NUREG–1423
Volume 10

A Compilation of Reports of The Advisory Committee on Nuclear Waste

July 1999 - June 2000

U. S. Nuclear Regulatory Commission

Figure 2. Underground Repository Infiltration Shield

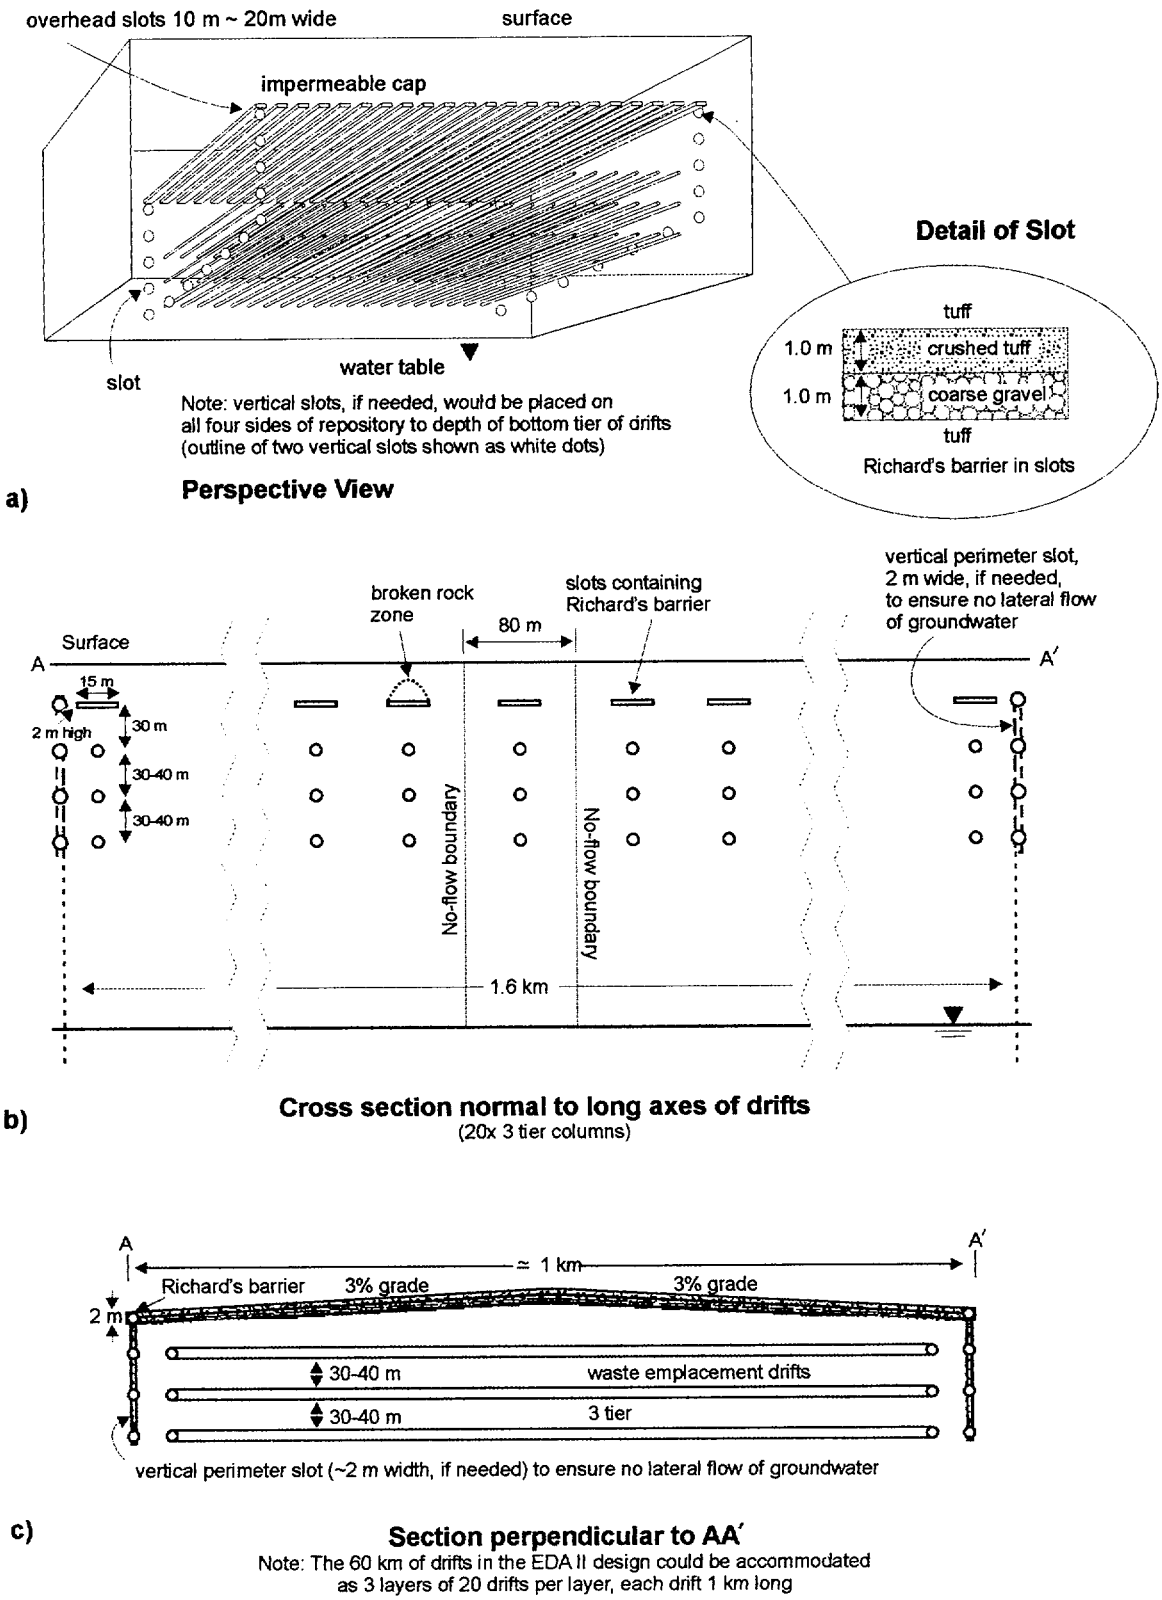
The infiltration shield concept is illustrated in Figure 2. In the example shown, the repository is laid out as a three-level system.[5] This alone, by reducing the plan area *(footprint)* of the

A single typical column of drifts was analyzed. This corresponded to the central column shown in the upper diagram in Figure 2, but with the upper slot replaced by a circular drift (see diagram in Appendix I). The flow conditions and rock mass properties were considered to be representative of those in the unsaturated zone at Yucca Mountain. It was assumed that the rock mass could be considered to behave as an anisotropic continuum (i.e., discrete fractures were not considered). A uniform vertical infiltration of 50 mm/yr (1096 x 10^{-5} m^3/d over the 80 m^2 potential capture area (per meter of drift) was assumed to occur 30 m above the top row of drifts. A wide range of hydraulic anisotropy was examined. For all anisotropies considered, at least 94% of the top infiltration bypasses the lower three (rows of) drifts. The fluid pressure head above the lower drifts is reduced because of the proximity of the overlying drift, thus enhancing the potential for diversion of water around the lower drifts.

This criticism can be circumvented if the upper drift is replaced by a slot, say, 2 m high and ~10 m—20 m wide. Each such slot could be inclined slightly, as shown in Figure 2, and backfilled so as to establish a *flow diversion barrier*, to ensure that any infiltration from above the slot would drain into the rock mass outside the perimeter of the repository. Excavation of the 15 m—20 m slot would serve a dual purpose. A zone of enhanced fracturing would tend to develop above the slot (this would be further enhanced during the thermal cycle after the repository is filled with waste.) Any water infiltrating into the zone would drain into the slot; any remaining flow would be directed into the rock mass away from the drifts. Thus, both mechanisms (capillary diversion around and fracture flow into the slot) act to prevent flow into the drifts.

The distinct possibility that the repository shield concept could reduce drift infiltration sufficiently to make the titanium drip shield (Figure 4) unnecessary — for a cost saving of $4.6 billion — strongly suggests that the repository shield concept deserves detailed study by DOE. Such a study should examine the implications of the multi-level arrangement (with overlying slots) on the optimum repository design.

Figure 5. Heat removed by continuous ventilation of waste-filled drifts during the pre-closure period ($2m^3/s$ air flow in a 5-m diameter drift corresponds to an air velocity of 20 ft/min, or 0.23 mph)

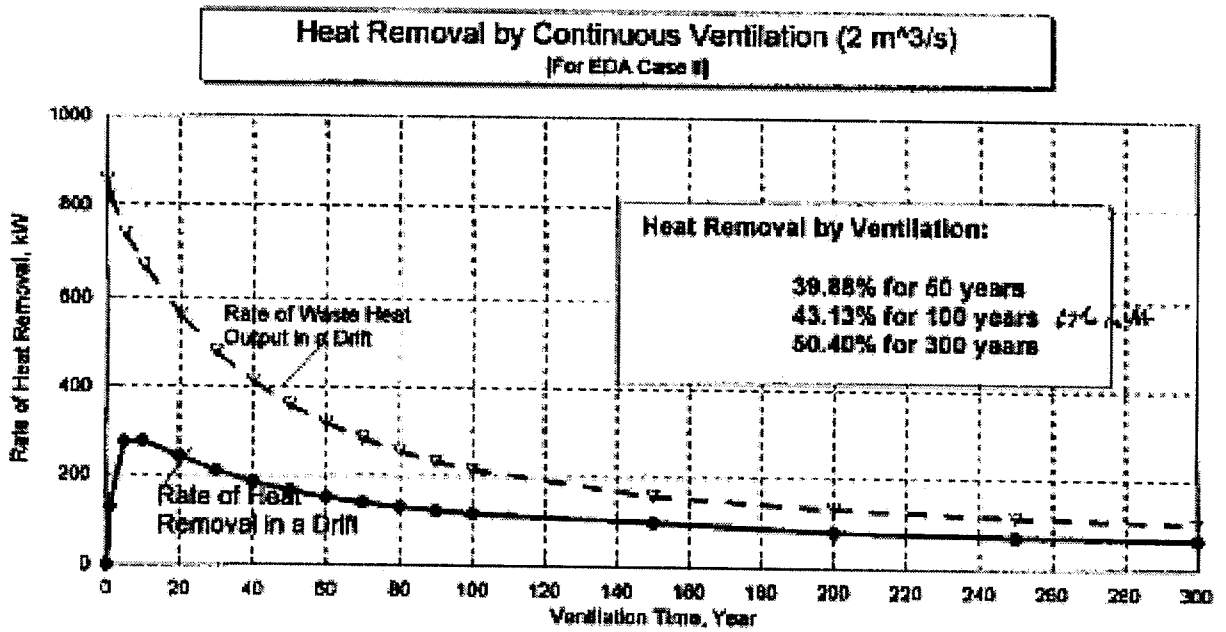
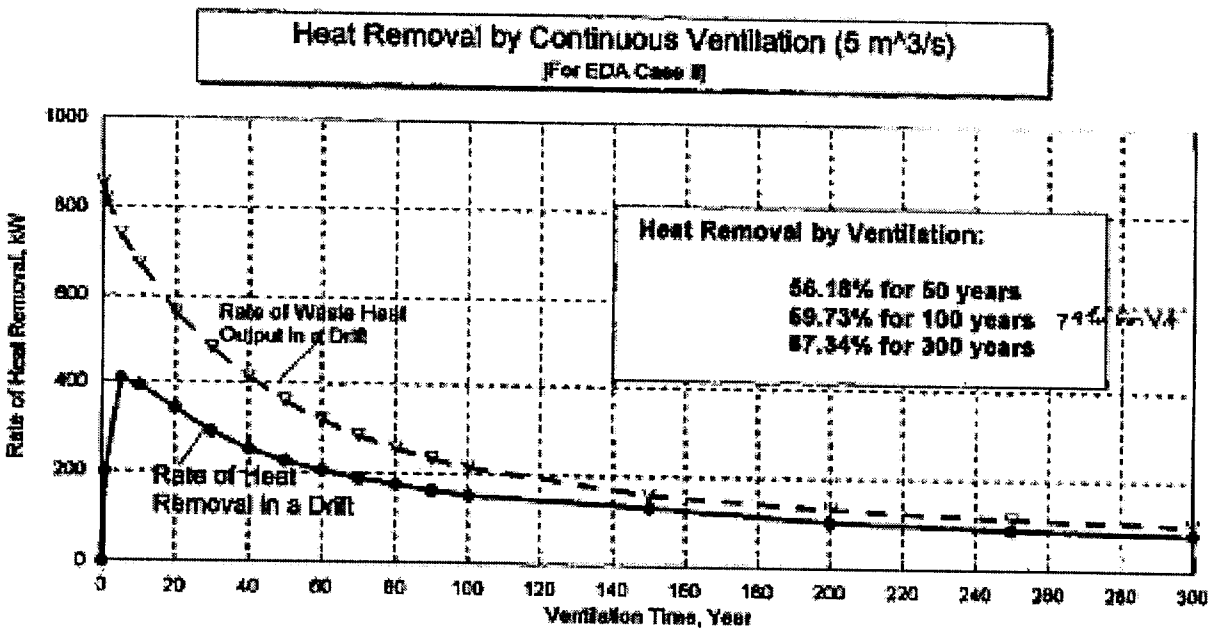
Figure 5 (kindly provided by the DOE, courtesy of R. Craun, 1999) indicates that drift ventilation can remove significant quantities of heat from the waste packages, especially during the first 50~100 years, when heat generation is most intense. Figure 6 (courtesy of D.G. McKenzie, April 1999) indicates that, with the EDA II design, drift ventilation of 2 m^3/s, and no aging of the waste:

Figure 11. Predicted Rock Mass Strength (Mohr-Coulomb) Envelopes and Modulii of Deformation for Lithophysal Tuff (Intact rock between lithophysae is assumed to have RGM 5 mechanical properties.)

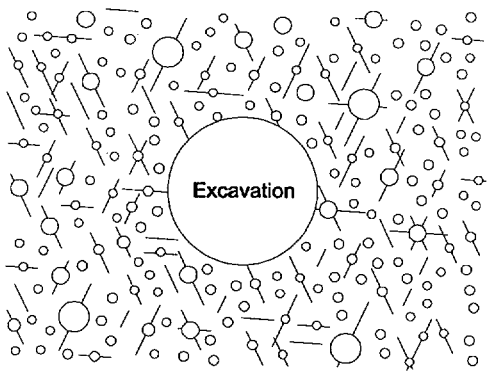
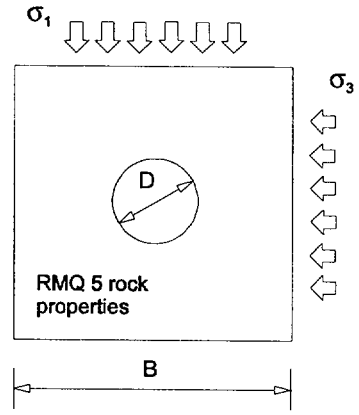
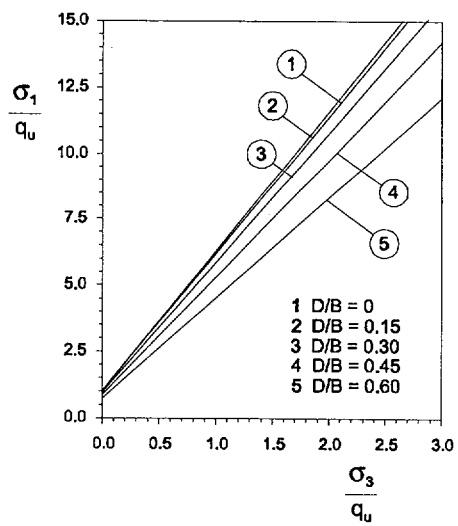
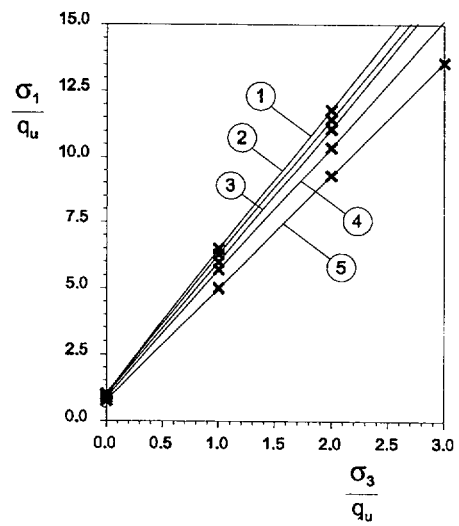
A brief analysis of the mechanical properties of lithophysal tuff (see Figure 11 and related discussion) suggests that the overall mechanical response to stresses (including thermal stresses) in these zones may be less influenced by joints and joint slip than is the case in the non-lithophysal zones. Thus, the rock mass strength in the lithophysal tuff may be somewhat higher, but the modulus of deformation will also be higher. Because the induced thermal stresses are directly related to this modulus, the *ratio* of stress:strength will change less. It seems, therefore, that from the mechanical stability perspective, drifts (e.g., for a multi-level repository) may be located in either or both lithophysal and non-lithophysal regions.

The model analyzed is shown in Figure 11(b). B is assumed to be the width of a cubical region containing one cavity, diameter D. Various ratios of B:D were considered. The reduction in strength of the cube of rock containing the cavity, compared to the strength of a cube without a cavity (B/D = 0) is shown in Figures 11(c) and11 (d).

It is recommended that laboratory tests be carried out on intact samples (taken between lithophysae) to establish the envelope corresponding to D/B = 0, and then to estimate an average value of D/B from exposures in drift walls. This information can then be used, with Figure 10(c), to establish an envelope for the rock mass strength.

Figure 1. Waste Package and Drift Design Cross Section

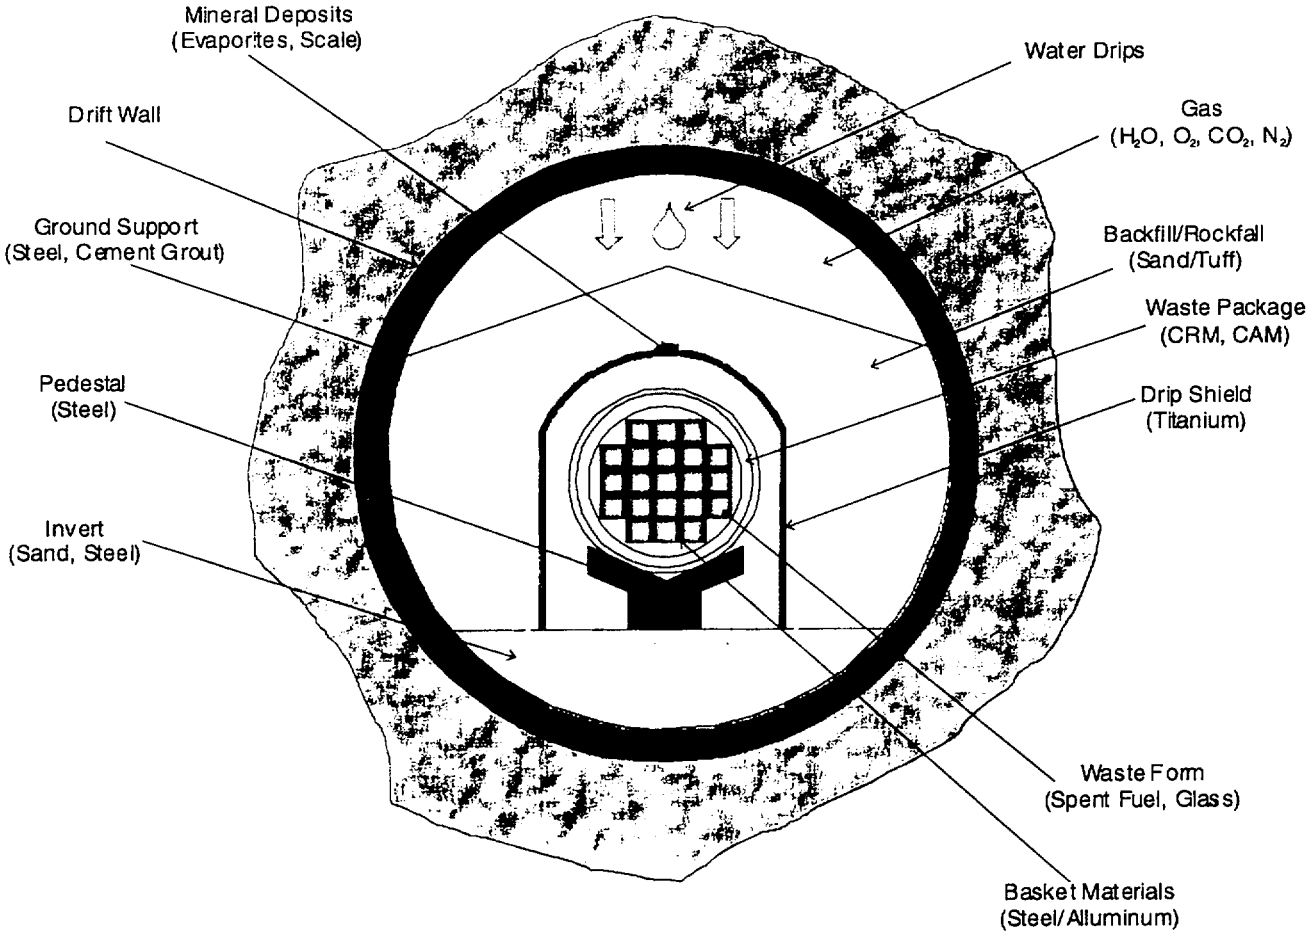
The current waste package design is shown in cross section Figure 1. The outer container has a 2 centimeter-thick wall of alloy C–22, whose composition is given in table 3. The inner container has a 5 centimeter-thick wall of stainless steel. It is expected that the stainless steel will corrode much faster than the C–22 once water breaches the C–22, and that in times far shorter than the repository licensing period it will be completely oxidized provided that the C–22 is in fact breached. As noted above, this steel could produce locally reducing conditions in the waste package or drift, and if oxidized, will add to the ionic iron content of the water. (Iron corrosion products would occupy more volume than the stainless steel from which they come, leading to potential adverse mechanical and structural effects. However, these effects are not considered here.) Unlike the steel in the waste package support and the steel invert, the iron ions from the stainless steel in the waste package container will be available for chemical reactions with the waste form itself at the water-waste interface.

There are extensive sources of information and data on the corrosion of high-nickel alloys, some of which are similar to C–22 (Betteridge, 1984; Schweitzer, 1996; INCO Inc., 1969 and 1995), but none for anything approaching the lengths of time being considered for the lifetime of the waste packages. The corrosion data that do exist for C–22 are very encouraging. However, pit, crevice, and stress corrosion are still matters of concern, and a better understanding of the mechanisms involved in these corrosion processes is needed before credit can be taken for the very long-term protection that DOE may postulate in its LA.
